Schedule H1 South Elevation

SPRING GARDEN WEST

DEVELOPMENT AGREEMENT

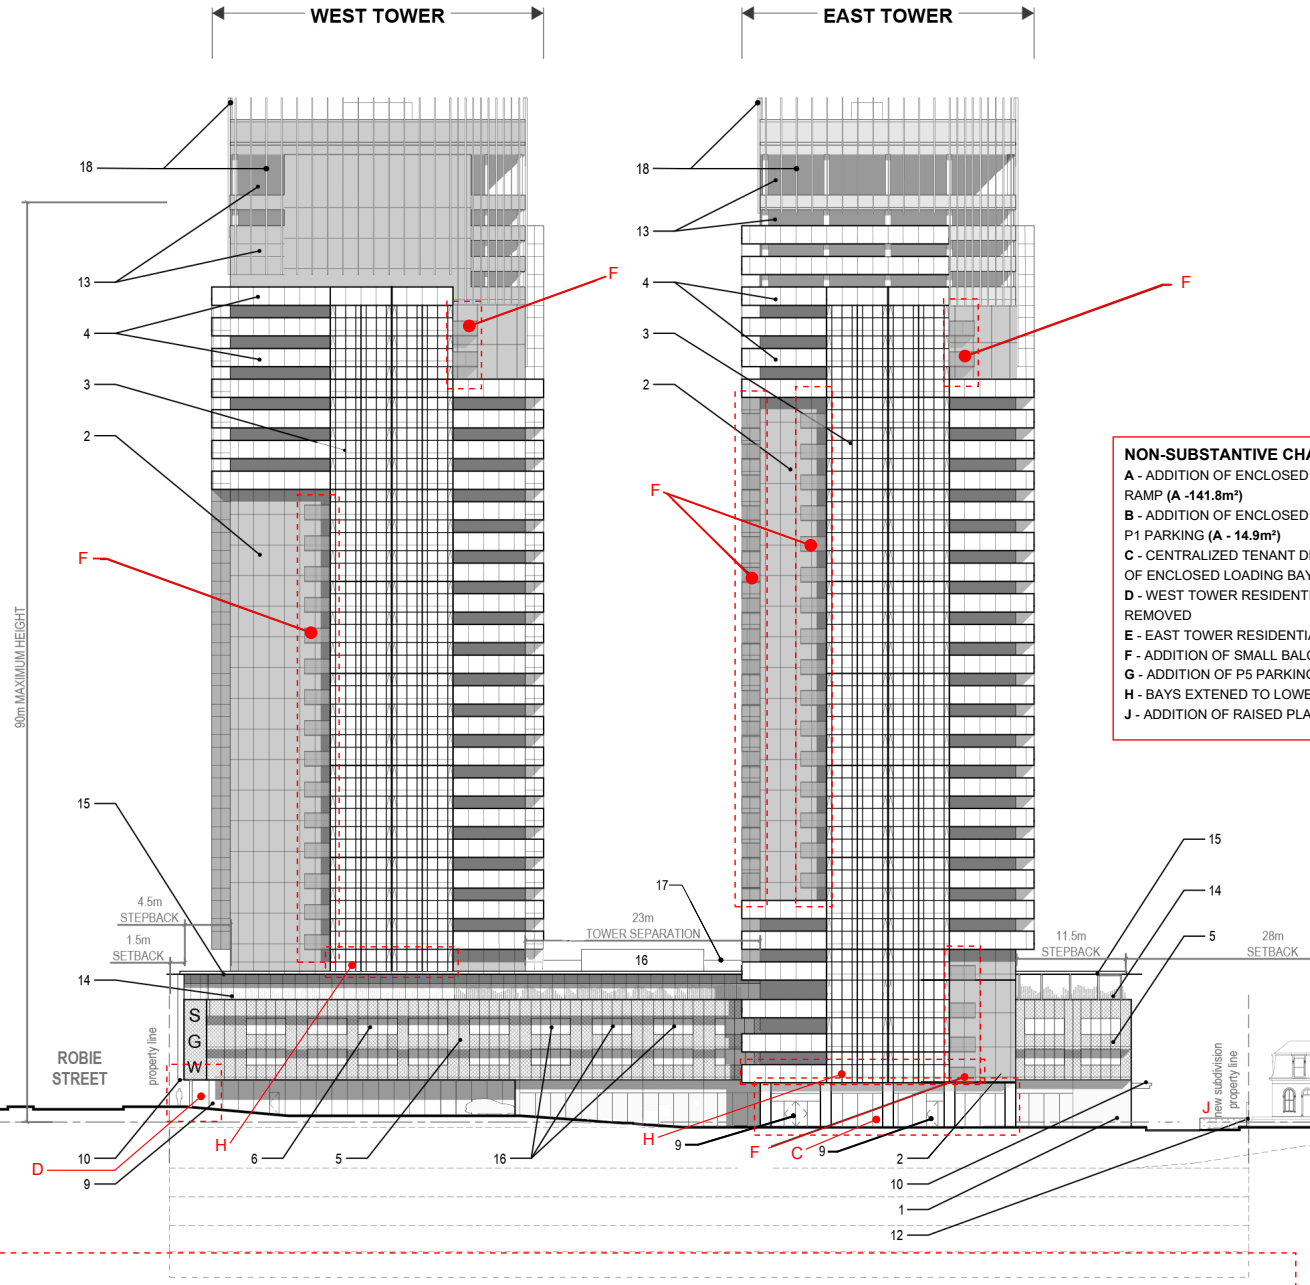
NON-SUBSTANTIVE CHANGES
A - ADDITION OF ENCLOSED TENANT PARKING RAMP (A - 141.8m²)
B - ADDITION OF ENCLOSED EXIT STAIR FROM P1 PARKING (A - 14.9m²)
C - CENTRALIZED TENANT DROP OFF IN PLACE OF ENCLOSED LOADING BAY
D - WEST TOWER RESIDENTIAL ENTRY REMOVED
E - EAST TOWER RESIDENTIAL ENTRY REMOVED
F - ADDITION OF SMALL BALCONIES
G - ADDITION OF P5 PARKING LEVEL
H - BAYS EXTENDED TO LOWER LEVELS
J - ADDITION OF RAISED PLANTER (HT - 1.2m²)
